Substantive response of the Local Highway Authority to a planning consultation received under The Development Management Order.

Planning Application Number: 23/00573/FUL

Application Address: Land To The West Of Normandy Way Hinckley Leicestershire

Substantive Response provided in accordance with article 22(5) of The Town and Country Planning (Development Management Procedure) (England) Order 2015:

Junction 2: A47 Normandy Way / Roston Drive (proposed with pedestrian crossing)

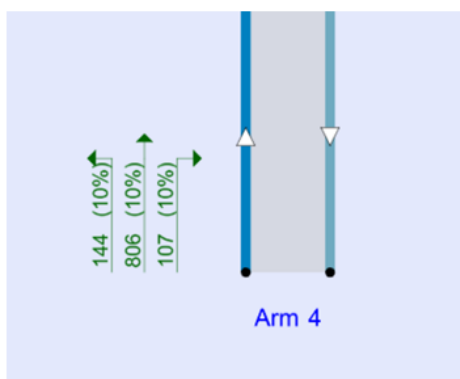
The LHA have a concern about this model relating to the proposed narrowing of the carriageway on Arm 1 (A47 North) which will result in the removal of the existing 2-lane exit. This means that traffic on Arm 4 (A47 South) will no longer be able to use both lanes to go ahead to A47 North (Arm 1).

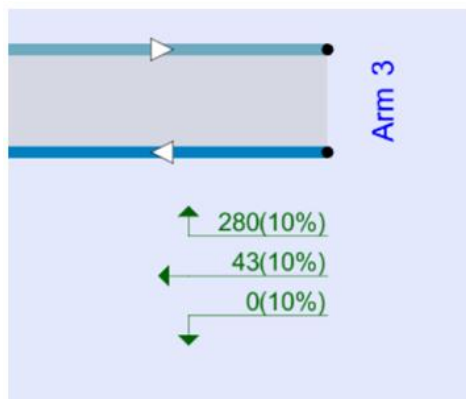
The traffic flows on A47 South are imbalanced, in the extract from the model shown below for example, 950 pcus will use lane 1 to go left/ahead and only 107 pcus will use lane 2 as it will no longer be possible to use both lanes to go ahead:

There are also imbalances in flows on Arm 3 where most traffic is turning right:

The ARCADY model assumes that approach lane flows are balanced, and corrections should be made to the model to account for unequal lane usage (e.g. as per the advice in the Barbara Chard “Arcady Heath Warning” which can be found at http://231618.vps-10.com/Home/docs/tec_arcadyHealthWarning.pdf). Alternatively, the use of “Lane Simulation” mode in the model should give more accurate results.
